File No.: GM-DP-2023.1 &
GM- DVP-2023.2

TO: Gambier Island Local Trust Committee

FROM: Ian Cox, Planner 2
Northern Team

SUBJECT: Concurrent Development Variance Permit & Development Permit Applications
Applicant: Stephen Delane
Location: West Bay Road, Gambier Island; PID 013-387-031
BLOCK 62 DISTRICT LOT 1297 PLAN 2848

ATTACHMENT 01b - Site Plan

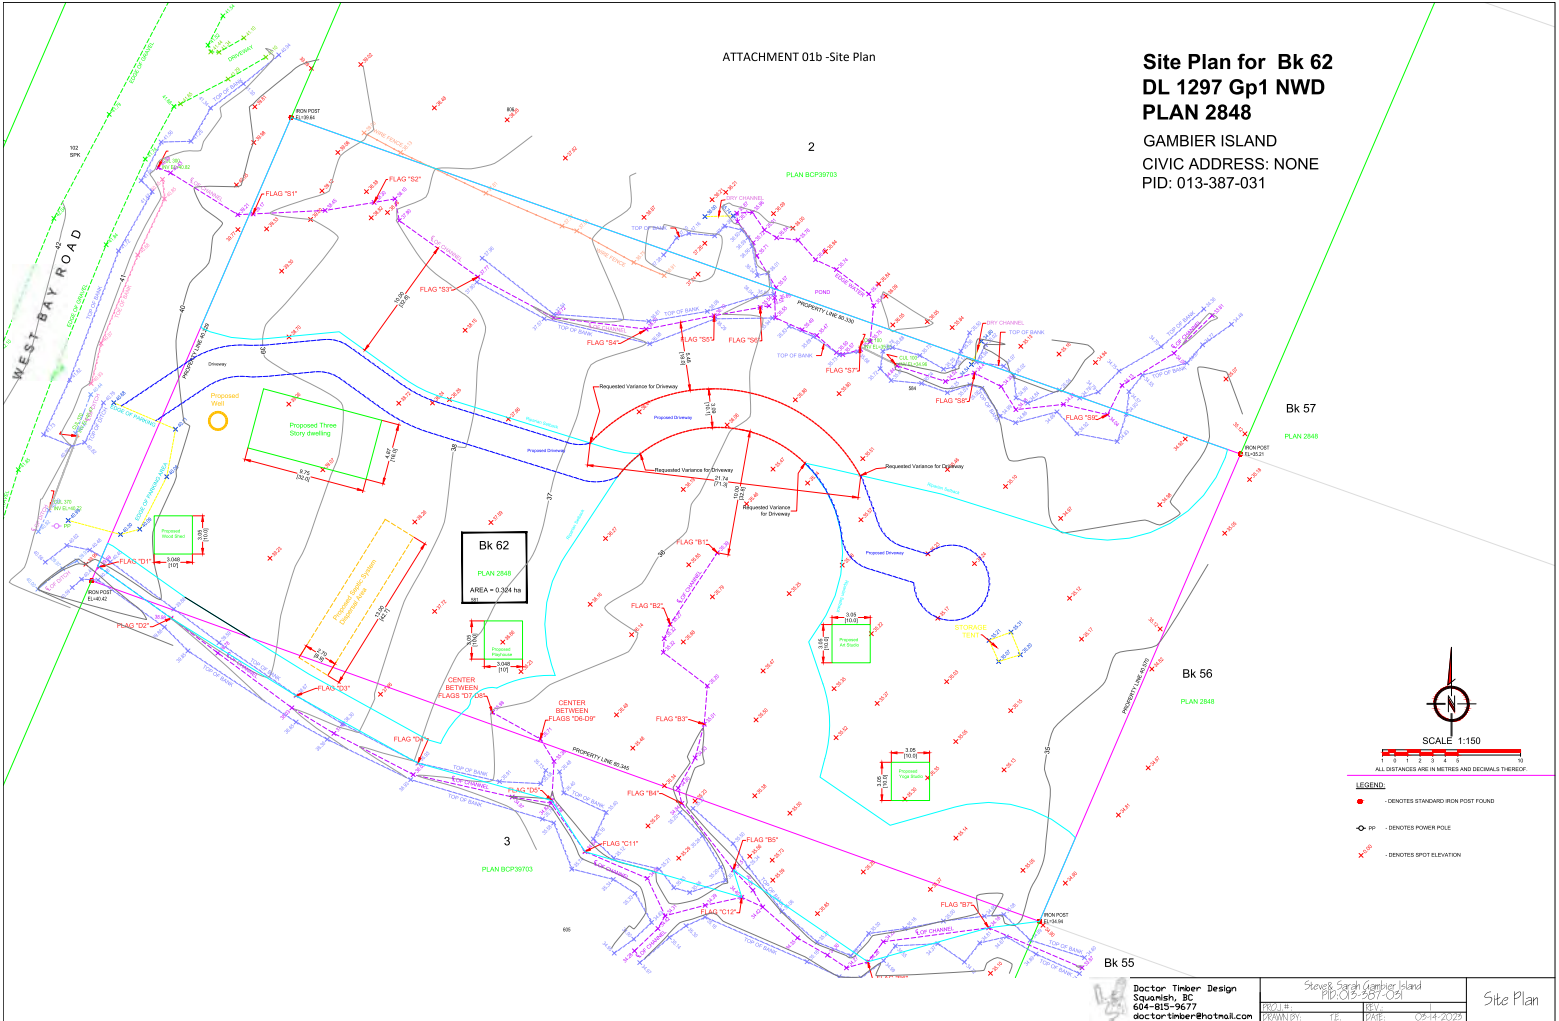
Staff does not recommend issuing the DVP, as the variance requests for the buildings and structures as submitted by the applicant in the site plan (**Attachment 1b**) are inconsistent with the plans included in the *RAPR* Report.

There is a discrepancy between the provincially accepted *RAPR* QEP Report plans and the most recent site plan as submitted by the applicant (**Attachment 2**); chiefly, there are more structures and in different locations on the plan than as included in the *RAPR* Report. The applicant is seeking variances for these additional structures. When local governments receive a notice of an accepted *RAPR* Report from the province, information is included which states that if development plans change, a new assessment and DP are required. For this reason, staff are recommending the LTC grant only the DP as it conforms with the Report (proposed DP in **Attachment 7**), and refuse the DVP which requests variances for siting of structures not considered in the Report.

However, the only structures considered in the *RAPR* Report are the residence (single family dwelling), septic system, alternate driveway configuration, and driveway - described in section 1 on page 4 of the *RAPR* Report and shown in the map plan on page 14. The other structures are not considered. For this reason and as mentioned earlier in the report, staff do not recommend issuing the DVP. The *RAPR* Report shows the residence and associated development in compliance with the 15 metre LUB setback.

Staff do not consider the DVP application to be consistent, because of the discrepancy between the requested variances and the scope of development as contemplated in the *RAPR* Report.
